CITY OF SOMERVILLE, MASSACHUSETTS
OFFICE OF STRATEGIC PLANNING & COMMUNITY DEVELOPMENT
JOSEPH A. CURTATONE
MAYOR

HISTORIC PRESERVATION COMMISSION

ALTERATION TO A HISTORIC PROPERTY STAFF REPORT

Site: 1 Westwood Road c.1929 Somerville Museum
Case: HPC 2015.073 Westwood Road Local Historic District

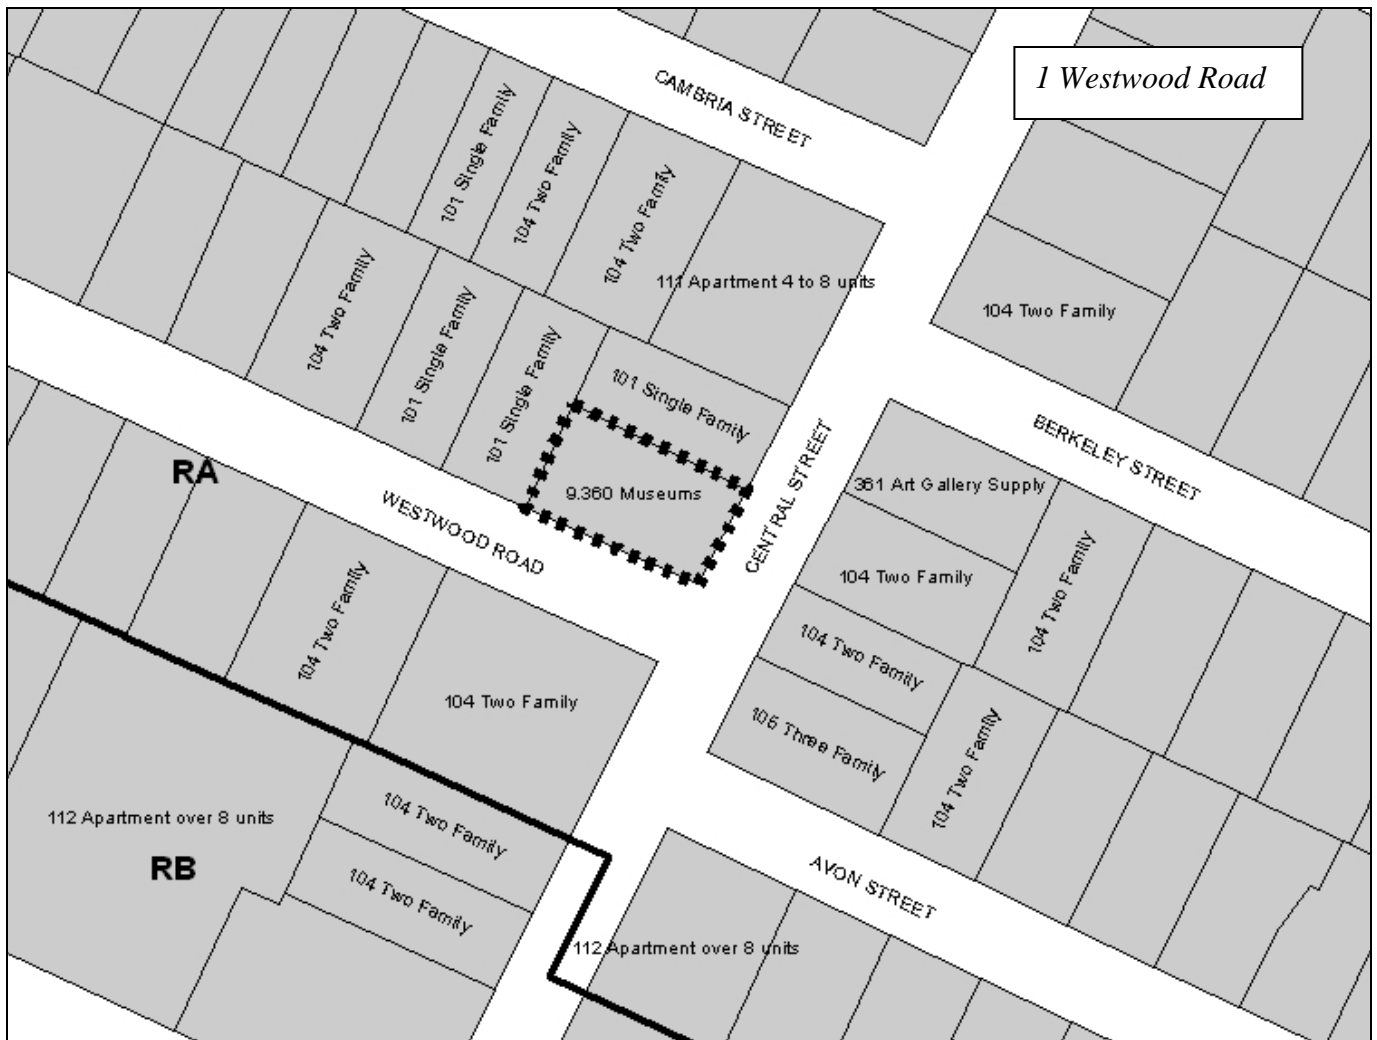
The proposed addition is not a replica of an earlier building. Attention has been paid to continue the cornice line and retain and reuse the existing windows in a new location. New, more prominent entry doors have been proposed. The proposed clapboard sided addition is 3 bays wide and 2 stories high fitting beneath the pediment on the rear side of the building. This section of the building currently has a centrally located entry door flanked by two 12/12 windows with casings that match the rest of the building and three windows above. The proposal has re-used some of the windows from the brick wall but cased them more narrowly with less of a lintel. A door to the LULA or elevator is located to the left hand side of the addition on Westwood Road while the entry for the able-bodied is located on the side of the addition facing Central Street. The ADA door has a large transom to illuminate the foyer, while the other door has a fan top arch reminiscent of the Central Street entry. The proposal is to re-install the Palladian window on the wall of the addition replicating its original placement on the side of the building. This does not meet with the MHC Restrictions. Generally speaking, Palladian windows are centered and often found in the tympanum or gable, over a main entry, or as part of a series of such windows and other openings. The proposed location on the side of the building raises questions as it is a very unlikely place for a Palladian window. Staff has asked for an explanation regarding the original placement and the origins of the window.

The addition would require the removal of some of the brick exterior walls of the building and the relocation of the existing windows.

3. The Westwood Road entry porch and stairs shall be demolished.
4. An approximately 6'3" by 22'3" addition with new entry steps shall be constructed as per plans.

5. Only the amount of brick masonry necessary to accommodate the needed changes shall be removed to accommodate the installation of the LULA on three floors: basement, ground and second floors as well the necessary allowance for the open passage between the areas noted in the plans.

6. The ground floor left-most window is to be retained *in situ*.
7. The existing Westwood Road entry door and other windows shall be salvaged and reused on the addition.

8. The other ground floor and the second floor windows shall be relocated to the new exterior.
9. The Westwood Road side of the building shall have three windows on the third floor and two windows on the second floor that either are re-used existing windows or replicated to match.

10. The window casings shall reflect the current size and proportions of the cast stone window surround on the masonry section of the building.
11. The cornice line shall reflect the existing cornice.

Circa 1934 image of 1 Westwood Road with Palladian window.

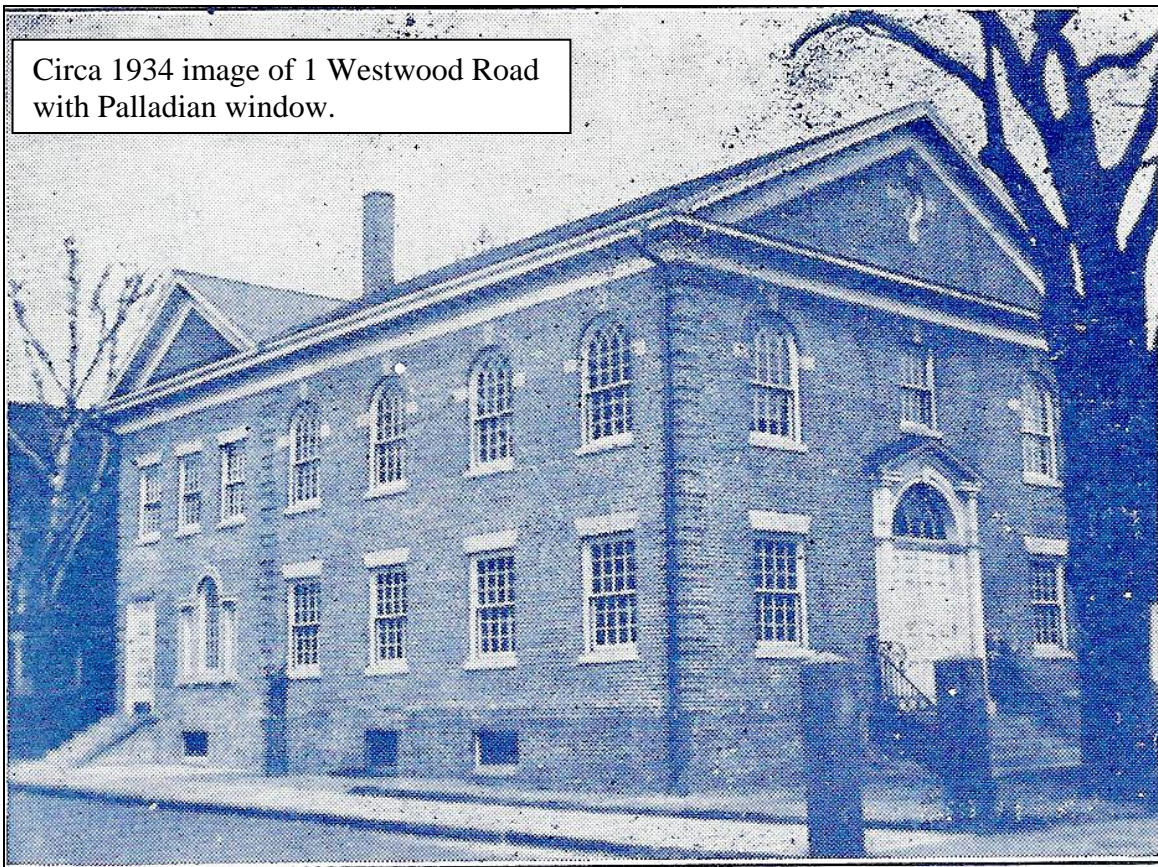
The proposal is more appropriate than the existing 1980s era steps and entry although some of the details still do not relate well to the building as a whole. Window casings are too delicate, and the location of the Palladian window is problematic since the location is neither period appropriate nor in keeping with the Preservation Restriction.

12. The Palladian window shall be relocated to the rear of the building facing the parking area as per MHC Preservation Restriction.
13. Historic Staff shall issue a sign-off upon completion of the project that this was done in accordance with the Certificate and approved plans and prior to the Somerville Historical Society receiving Inspectional Service Division sign off.
